Erosion and Riverbed integrity at the Low-Level Outlet for the Springbank Off-Stream Reservoir Project

SR1 Concerned Landowners Group (“SCLG”)

February 2021

Detail of Low Level Outlet works from drawing 73396A-111, Stantec General Reservoir Overview, Springbank Off-Stream Storage Project Preliminary Design Report, December 2020

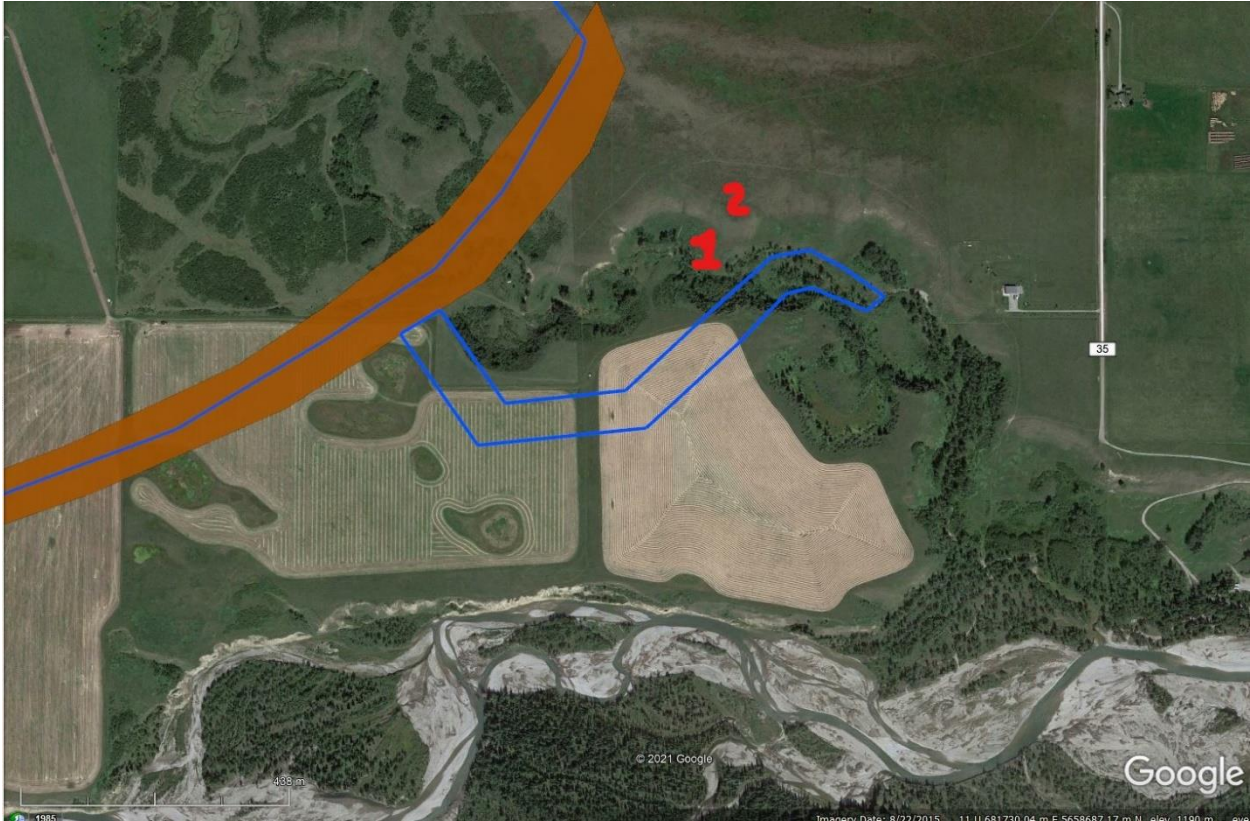
Description of operation of Low Level Outlet from Stantec December 2020 Preliminary Design Report. 27m³/s is more than 3 times the average annual flow rate for the Elbow River in this stem of the river which is 8m³/s.
